OIL CONSERVATION DIVISION

RE: Discharge Plan Inspections
GW-187, GW-208. and GW-233
San Juan and Rio Arriba Counties, New Mexico

ATTACHMENT NO.2 - WFS GW-208
Hart Mountain COMPRESSOR

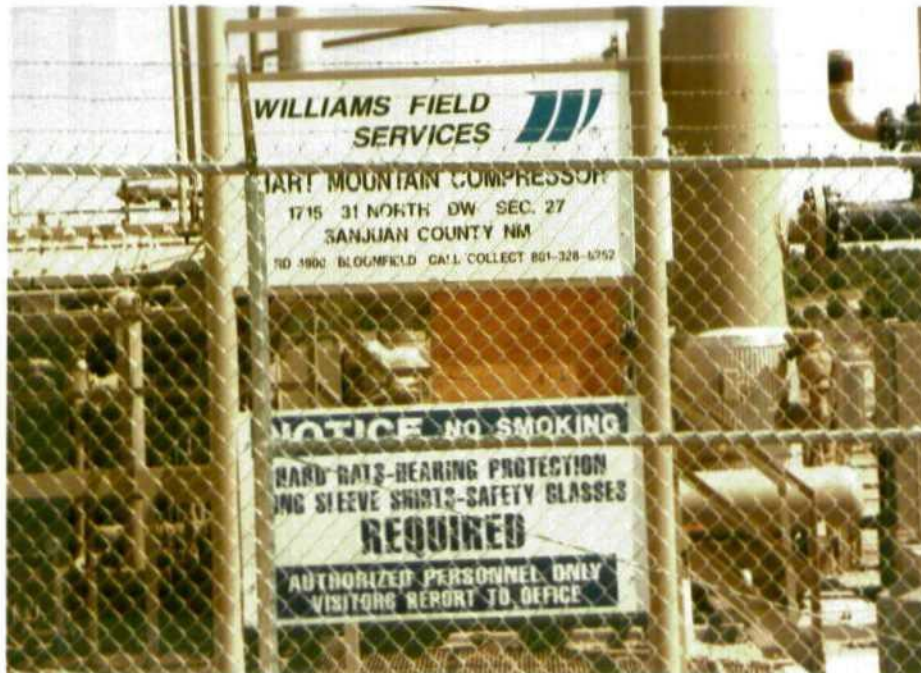
A. Overall the site appears to be in compliance with the OCD discharge permit GW-208 - However, housekeeping is a concern. (See photo GW-208 photo No. 03 date: 06/04/96) , Also this tank is in need of a label.
